Work Order ID 87006

Item ID: D2580-1 Accept *N900040100* Setup Start *NS1*
Revision ID: Stop *NS2*
Item Name: 205 Skidtube bent detail
Start Date: 7/09/12 Start Qty: 4.00 *4* Cust Item ID:
Required Date: 8/10/12 Req'd Qty: 4.00 *4* Customer:
Reference:

DRAWING NO. D2580	TITLE 205 SKIDTUBE ASSEMBLY	REV. E	DART AEROSPACE LTD ENGINEERING ORDER		D.E.O. NO. D2580-E-1	SHEET NO. SHEET 1 OF 1	SCALE NTS
DRAWN <i>DP</i>	CHECKED <i>ASS</i>	MFG. APPR. <i>EC</i>	APPROVED <i>[Signature]</i>		DE APPR. <i>[Signature]</i>		
DATE 11.12.13	DATE 11.12.13	DATE 11.12.13	DATE 11.12.13		DATE 11.12.13

CHANGE ALL C'BORED WELDED CROSSBOLT SPACERS TO SWAGED SPACERS

SECTION F-F D5-5
SCALE 5X

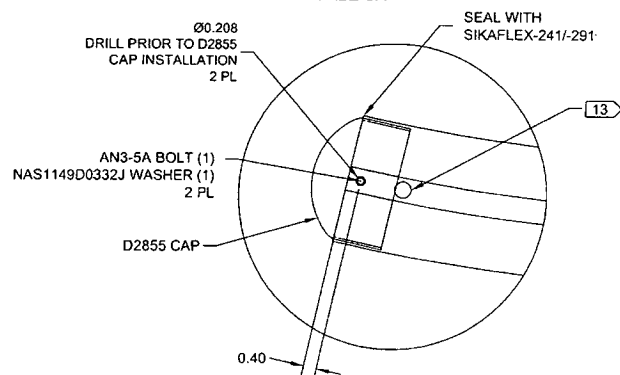
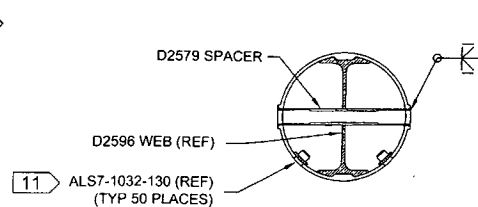
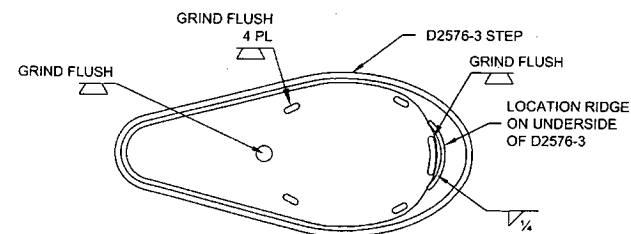
AFTER DRILLING AND BENDING ASSEMBLY
PERFORM THE FOLLOWING FOR Ø0.508 HOLES ONLY:
1. CHAMFER HOLE 0.050 X 45°
2. INSERT D2579 SPACER (24 PLACES)
3. WELD INTO PLACE AND GRIND FLUSH
4. C'BORE D2579 SPACER TO Ø0.437 X 1.00 DEEP

1. INSERT D4202-1 SPACER, 20 PL (-041) OR 20 PL (-045) OR 25 PL (-047)
2. SWAGE TO Ø0.437 X 1.00 DEEP PER QSI 002
3. TRIM / GRIND FLUSH PER QSI 002

SECTION I-I D5-7
SCALE 5X

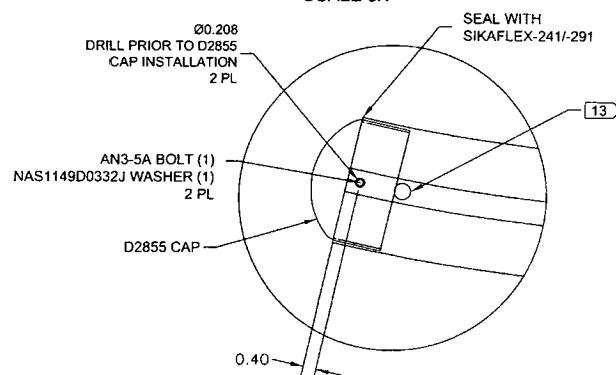
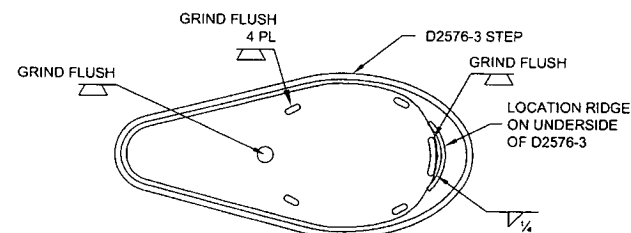
- AFTER DRILLING AND BENDING ASSEMBLY
PERFORM THE FOLLOWING FOR Ø0.508 HOLES ONLY:
1. CHAMFER HOLE 0.050 X 45°
 2. INSERT D2579 SPACER (25 PLACES)
 3. WELD INTO PLACE AND GRIND FLUSH
 4. C-BORE D2579 SPACER TO Ø0.437 X 1.00 DEEP

SECTION B-B, F-F, I-I
NOT TO SCALE

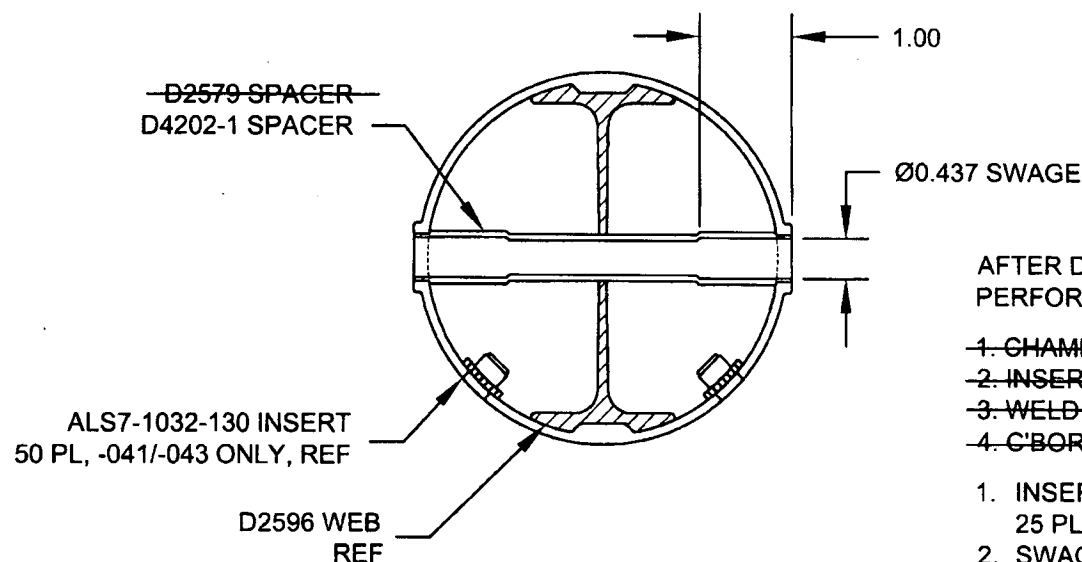
SECTION B-B, SECTION F-F, & SECTION I-I ARE AMENDED AS FOLLOWS
FOR ALL HOLES THAT WERE ORIGINALLY C'BORED:

AFTER DRILLING AND BENDING ASSEMBLY
PERFORM THE FOLLOWING FOR Ø0.508 HOLES ONLY:

1. CHAMFER HOLE 0.050 X 45°
2. INSERT D2579 SPACER (20 PLACES)
3. WELD INTO PLACE AND GRIND FLUSH
4. C'BORE D2579 SPACER TO Ø0.437 X 1.00 DEEP

WELD 4X D2579 SPACERS PER DWG
IN LOCATIONS MARKED "NO C'BORE".
REF SHEET 4 OF DWG.
